Spring Creek Precinct Structure Plan

# Response to the Panel Report for Surf Coast Planning Scheme Amendment C114

October 2017

Figure 1: Waterway corridors and drainage assets

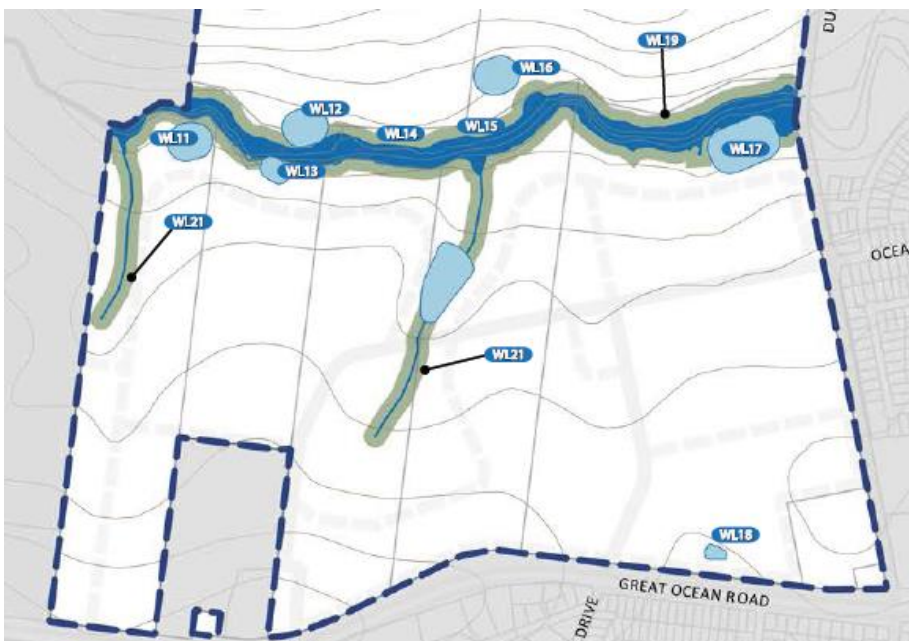
- Waterbodies WL15 and WL21 (200-220 Great Ocean Road) should be deleted as they are man-made, pose a potential safety risk and are not suitably located to provide effective management of water flows from the catchment. They should be replaced by a waterbody further downstream.

- Council should review the extent of WL01 (225 Grossmans Road) in discussion with the landowner.
- The PSP should provide clarity and guidance for the assessment and exercise of discretion by Council of alternative water management systems proposed by developers.

- The extent of WL01 affecting 225 Grossmans Road has not been reviewed as the mapping was based on waterway and flood extent information provided by the CCMA. The waterway is a designated waterway forming part of the northern tributary of Spring Creek. The landowner did not submit any evidence to justify why it would be appropriate to remove the waterway and has not made any further submissions.

Amend PSP Plan 8 and Table 5 to:

- delete Waterway WL21 from Properties 12 and 13 and relocate Water body WL15 to a downstream location
- relocate Water bodies WL11, WL12, WL13 and WL17 to avoid encroachments onto Crown land and to avoid or minimise native vegetation losses

Figure 2: 200-220 Great Ocean Road

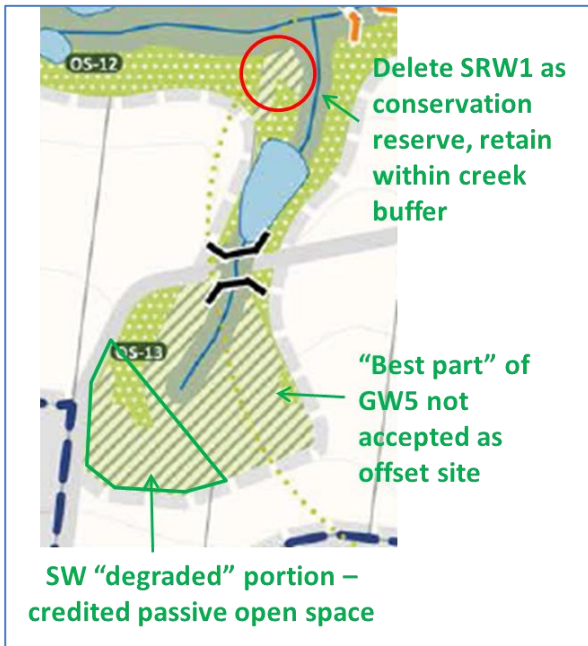
A reduction in size of the reserve would result in greater losses of trees, create greater edge effects due to loss of buffers, complicate Bushfire Attack Level (BAL) setbacks and increase offset requirements due to additional vegetation removal which is avoidable. For these reasons Council is reluctant to change its position about the size of the conservation area as shown on the exhibited PSP.

Without a record of public funding, Council cannot mandate the retention of the vegetation. As the Panel recommended retention of this vegetation to provide habitat benefits, but not as part of a conservation reserve, it is recommended that the vegetation be included in the NVPP as vegetation identified for 'practical retention'. Given the vegetation would be contained within the creek buffer, this is viable option.

Remove the patch of SRW1 at 200 Great Ocean Road as a conservation reserve and include the patch in the NVPP as vegetation identified for 'practical retention'.

Figure 3: Spring Creek buffer

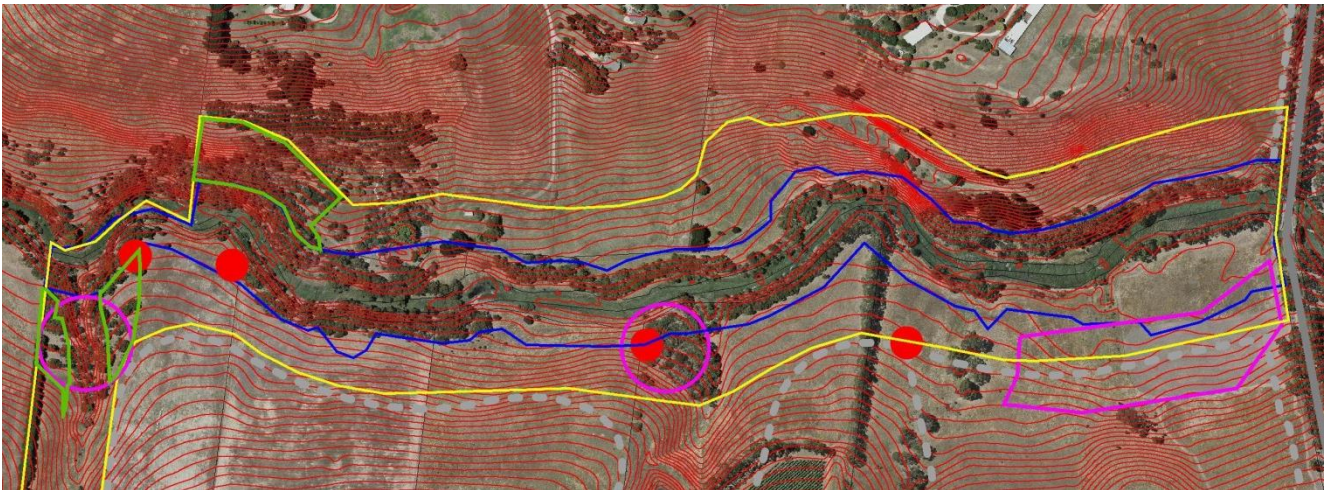
- The waterway buffers are the result of the crude application of fixed width buffers that do not demonstrate a site specific response to opportunities and constraints of the precinct, nor a response to an identified need for passive open space.

- It is not clear how the active open space needs of future residents will be met and funded.
- The open space provision should be reviewed to provide local parks within 400m of at least 95% of all dwellings in accordance with the PSP Guidelines. This minimum standard is achievable if the waterway buffer widths are reduced.

Having considered relevant open space and waterway planning provisions and site specific information in relation to slope, flood extent, native vegetation, Aboriginal cultural heritage, geotechnical aspects and space required to accommodate drainage assets, local parks and pathways/trails it is considered that creek buffers of 75 metres along Spring Creek and 50 metres along the northern tributaries are justified (the extent of open space along the waterway at 161, 165 and 195 Grossmans Road is discussed at section 2.6.2).

Figure 5: 161, 165 and 195 Grossmans Road

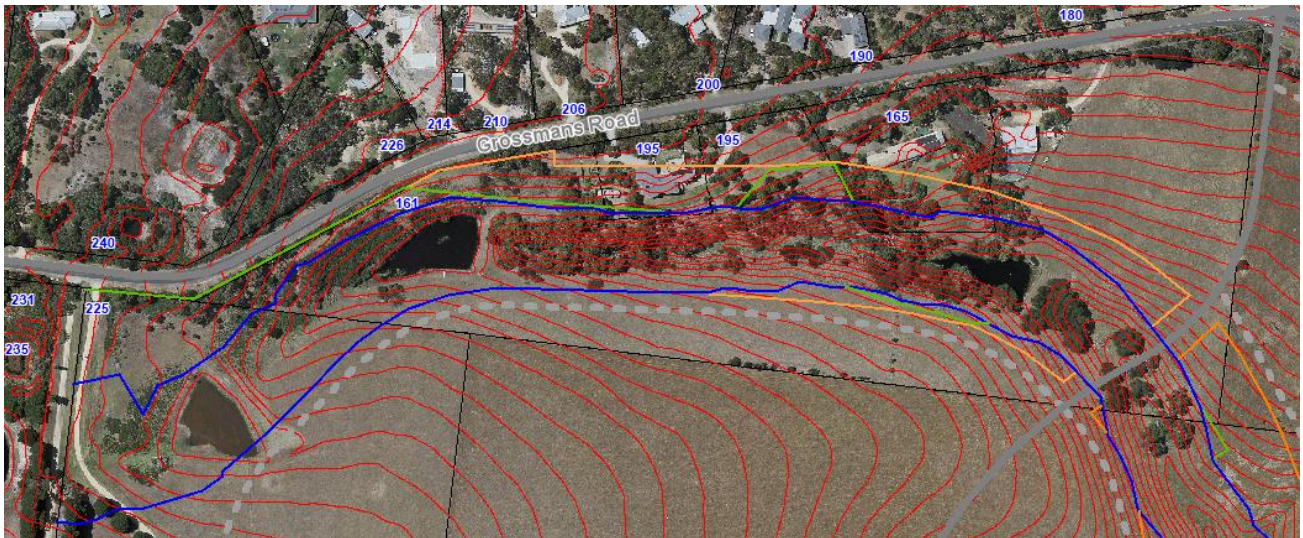
Having considered submissions from landowners that vegetation at 161 and 195 Grossmans Road identified as remnant was mostly planted or regrowth, the Panel recommended that the status of this vegetation be reviewed and the NVPP amended accordingly.

Further to the review of the extent of native vegetation on the properties at 161, 165 and 195 Grossmans Road, the extent of Open space areas OS-01 and OS-02 affecting the properties was also reviewed. It was put to the Panel by the affected landowners that the public open space included in OS-01 does not have any meaningful purpose, unreasonably impacts on the developable area of the land, does not provide a connection to the west and does not link in with any open space within the low density residential estates to the north.

As shown on the exhibited PSP and the aerial photo below, the property at 161-195 Grossmans Road (property 3 in the PSP) is encumbered by a waterway/drainage reserve, conservation reserves and open space, leaving 46% of the land available for development. The existing dwelling would be located within the proposed open space reserve. The property at 165 Grossmans Road (property 2 in the PSP) is encumbered by a waterway/drainage reserve and open space and has a developable area of 65%. A service road within a 13 metre wide road reserve is required to be provided along Grossmans Road to provide access to future lots.

Figure 6: Proposed lot size distribution (concept plan only)

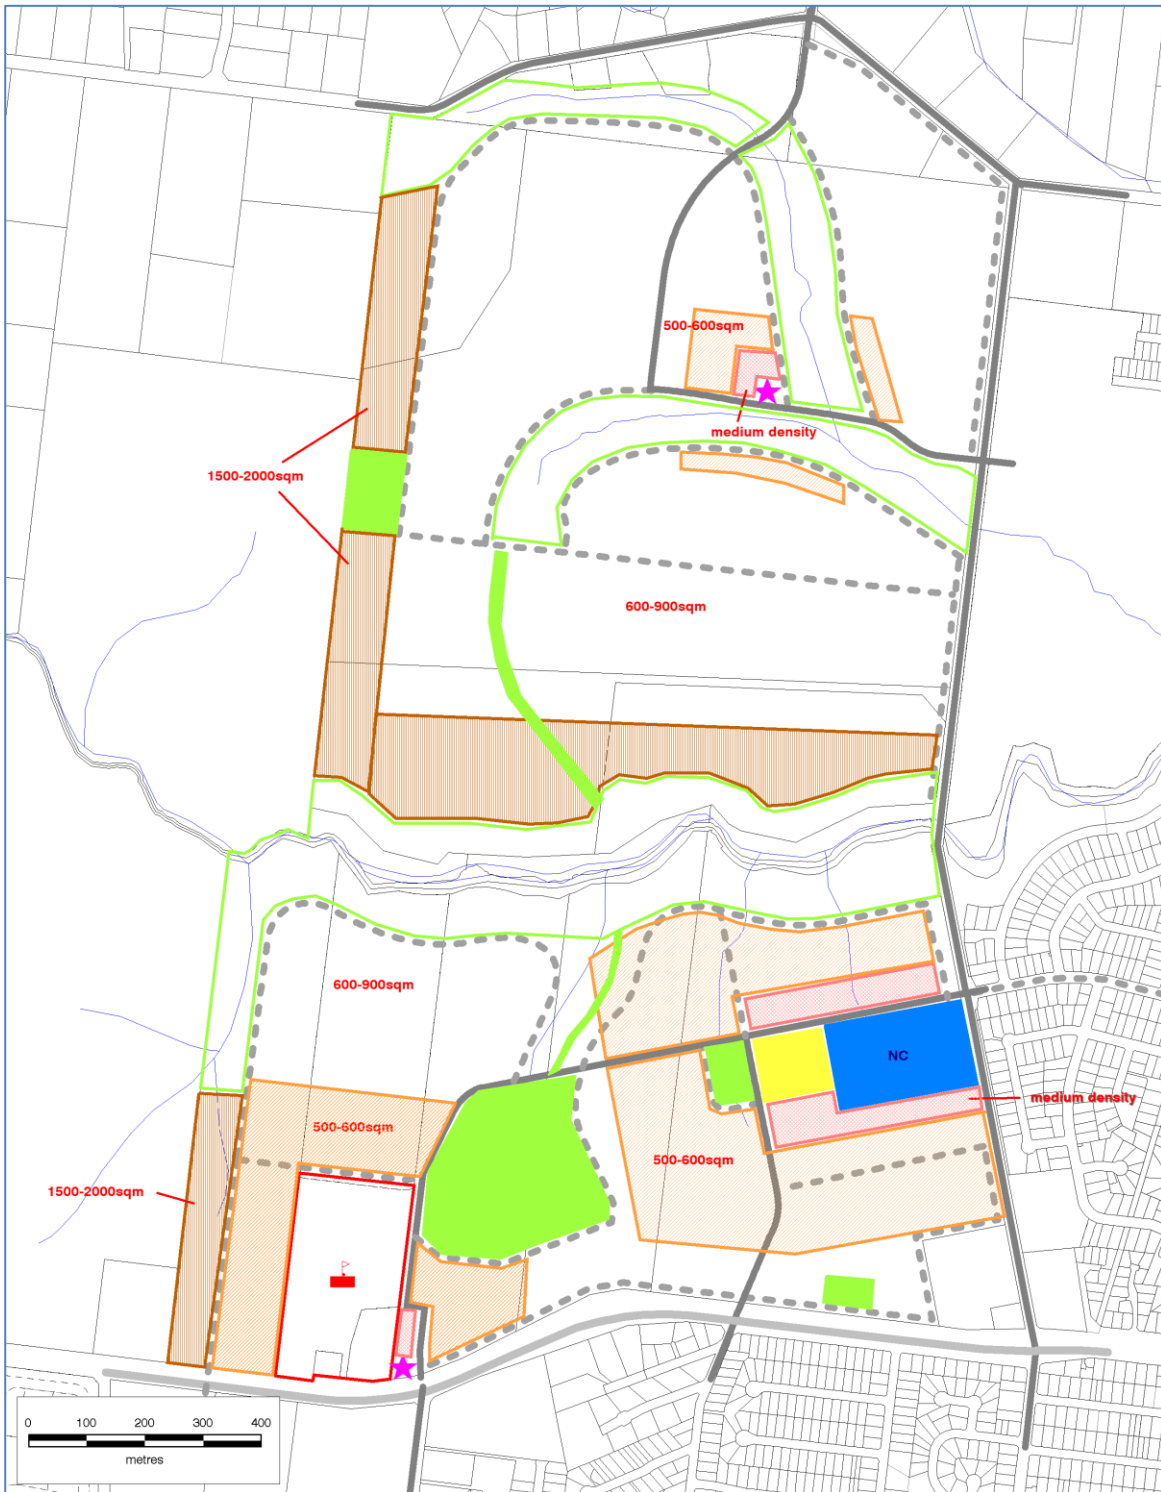
The Panel considered that the PSP does not provide for the meaningful delivery of housing diversity, particularly in the southern portion of the precinct. It recommended that the overall dwelling density across the precinct be increased from 10 to 12-13 dwellings per hectare by providing more lots of less than 600m<sup>2</sup> within a reasonable walking distance of the Neighbourhood Centre (NC) and school (Christian College), subject to any specific site constraints. The Panel accepted that a lower density than the state average of 15 dwellings per hectare for growth areas is warranted (and supported by Clause 21.08-2), however considered a density of 10 dwellings per hectare insufficient. It believed that higher densities are capable of being achieved without eroding the topographical and environmental setting of the precinct.

There is scope to reduce the lot sizes along Grossmans Road from 1,500-2,000m<sup>2</sup> to 600-900m<sup>2</sup>. Land to the northeast of Spring Creek on Grossmans Road has been earmarked for re-subdivision into conventional residential lots in accordance with the Briody Drive West Development Plan. Providing large lots along the south side of Grossmans Road would therefore be incongruous with planned development to the north. Furthermore, the development potential of the properties, in particular 165 and 195 Grossmans Road, is constrained by encumbered land required for conservation, open space, waterway and drainage assets, the location of existing dwellings and the need to provide a service road in order to protect significant roadside vegetation. Reducing the lot size to 600-900m<sup>2</sup> would increase the lot yield from a potential 35 lots to 80-90 lots and allow for a more appropriate integrated development with an internal service road to allow the retention of roadside vegetation on Grossmans Road.

Amend Plan 3 (and all other relevant plans in the PSP and UGZ1) and make consequential changes to the land use budget tables, to show:
